PROPOSED CHANGE TO APPENDIX A
TECHNICAL SPECIFICATIONS OF
FACILITY OPERATING LICENSE NPF-37

Revised Page: 3/4 3-45

TABLE 3.3-7

SEISMIC MONITORING INSTRUMENTATION

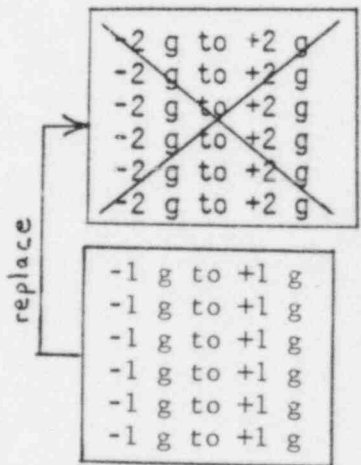
This change is requested because the seismic instrumentation has been alarming with no indication of a seismic event. It has been determined that this problem is a result of the low alarm setpoint (0.02g) being only 1% of the full scale range (2.0g) of the sensors. If the full scale range of the sensors is reduced while maintaining the same alarm setpoint of 0.02g, a larger signal will be required to reach the same alarm setpoint.

With the proposed change of the measurement range, the seismic monitoring system will still be capable of detecting a 0.02g event as described in section 3.7.4.3 of the Byron/Braidwood FSAR. The system will still detect an operating basis earthquake (0.09g) and a safe shutdown earthquake (0.2g) as described in sections 2.5.2.6 and 2.5.2.7 of the FSAR. Also, the seismic monitoring system will still meet the requirements of ANSI N18.5 and NRC Regulatory Guide 1.12.
